BID MEMO 01

<u>Saints - Cafeteria & Viewing Area</u>

REVISION #01

New Orleans Saints Viewing Area and Cafeteria Expansion 5800 Airline Drive Metairie, Louisiana 70003

DRAWN BY I WDG G1.12

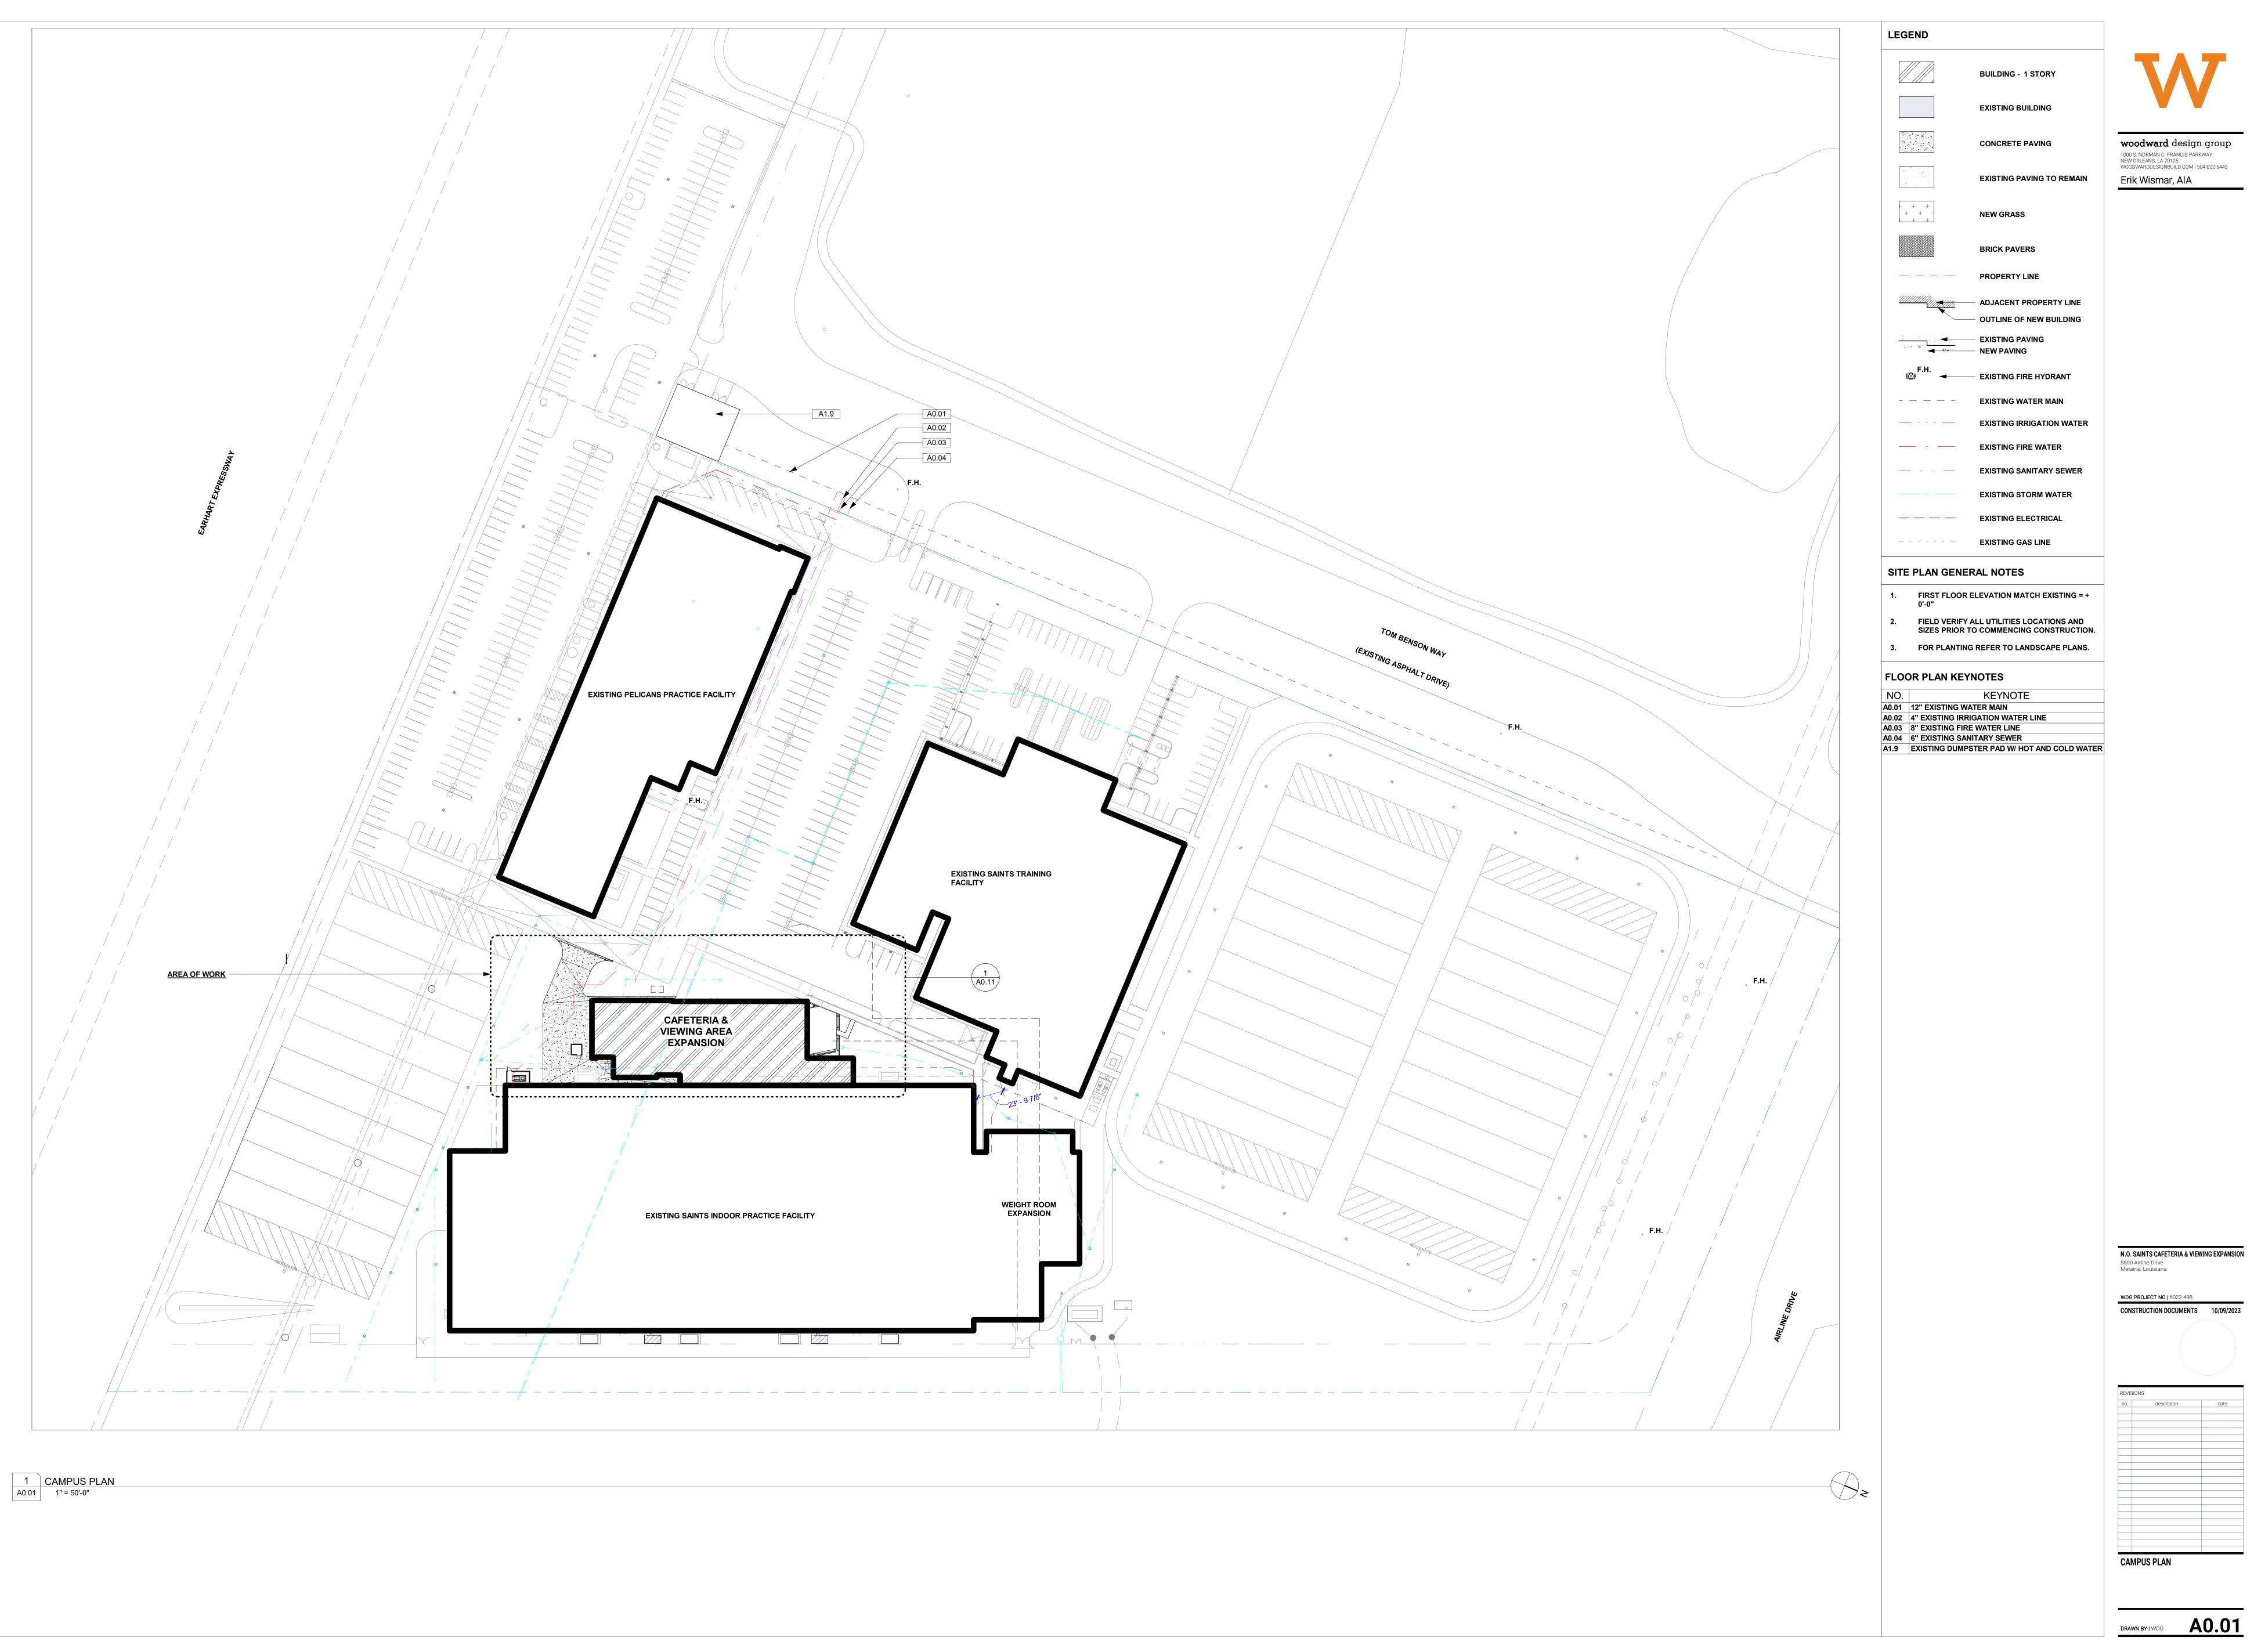
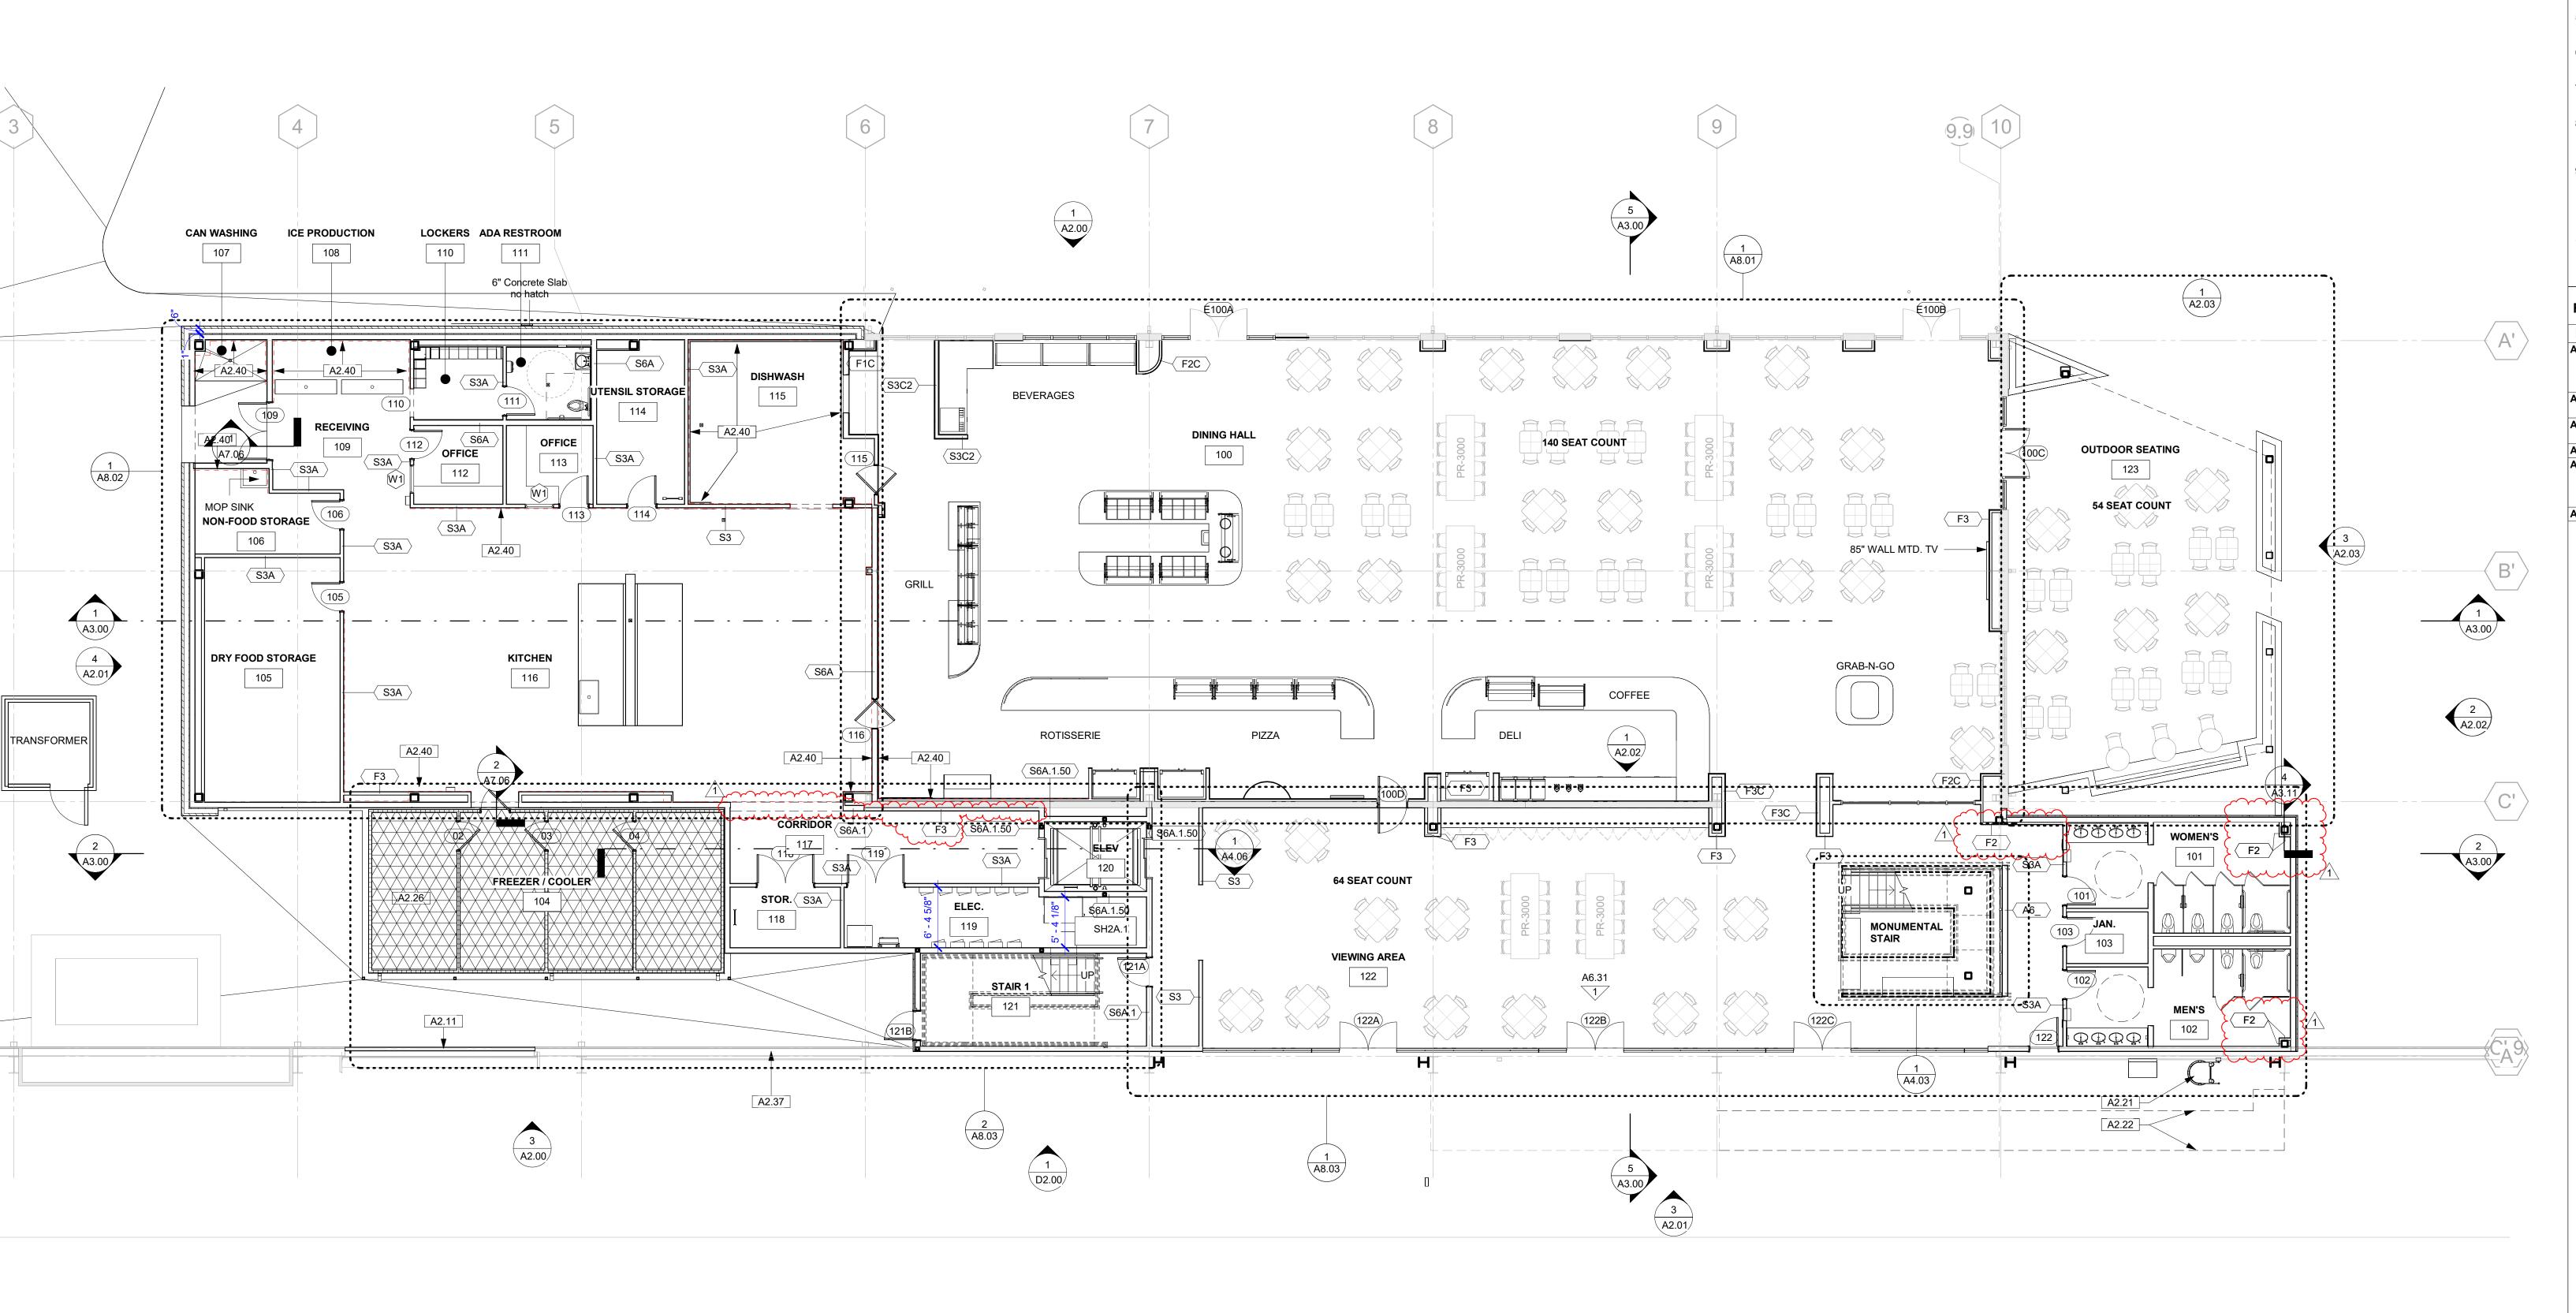
- Existing and New column grid symbols identified Go.01
- Egress data has been corrected G1.11
- Wall types adjusted at corridor 117 added at restrooms A1.11 & A8.03
